Access Compliance Report Public Rights-of-Way (Curb Ramps)

Main Street: CHAPMAN_AVE Cross Street: NEARING_DR Location: S

ADA ID: RPAT211130120705 Ramp Type: Type 4 - Parallel Initial Pass/Fail: Fail Overall Compliance: No Severity Score: 2

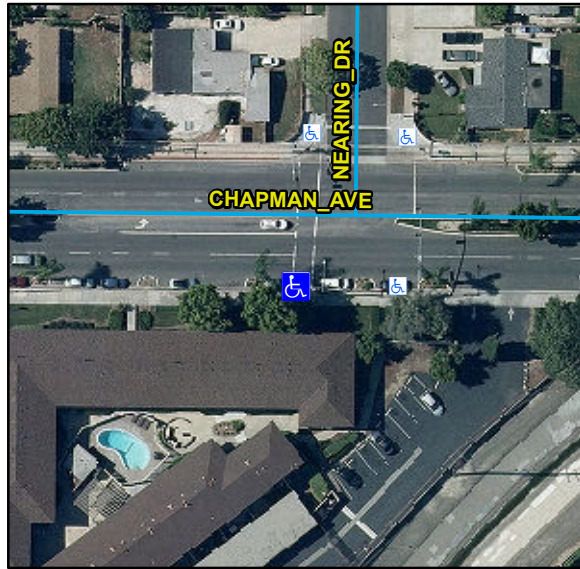
Compliance	Description	Data	Compliance	Description	Data
N/A	Ramp Length LT (in)	108	N/A	Ramp Length RT (in)	96
Yes	Ramp Width LT (in)	82	Yes	Ramp Width RT (in)	81
Yes	Ramp Run Slope LT (%)	6.3	Yes	Ramp Run Slope RT (%)	4.1
No	Ramp Cross Slope LT (%)	4.5	No	Ramp Cross Slope RT (%)	2.3
N/A	Landing Present	N/A	N/A	DWS Provided	N/A
N/A	Landing Length (in)	N/A	N/A	DWS Contrast	N/A
N/A	Landing Width (in)	N/A	N/A	DWS Length (in)	N/A
N/A	Landing Run Slope (%)	N/A	N/A	DWS Full Width	N/A
N/A	Landing Cross Slope (%)	N/A		DWS Offset Type	N/A
N/A	Landing Movement Obstructed?	N/A	N/A	DWS Offset Left (in)	N/A
	Landing Movement Type	N/A	N/A	DWS Offset Right (in)	N/A
N/A	Landing Shared	N/A			
N/A	Clear Space	N/A			
N/A	Clear Space To Crosswalk (in)	N/A			
N/A	Marked Crosswalk 1	Yes	N/A	Marked Crosswalk 2	N/A
	Crossing 1 Direction	N		Crossing 2 Direction	N/A
	Marked Crosswalk 1 Width (in)	120		Marked Crosswalk 2 Width (in)	N/A

Remove & Replace Entire Ramp.

R304.5.3, STD 1115
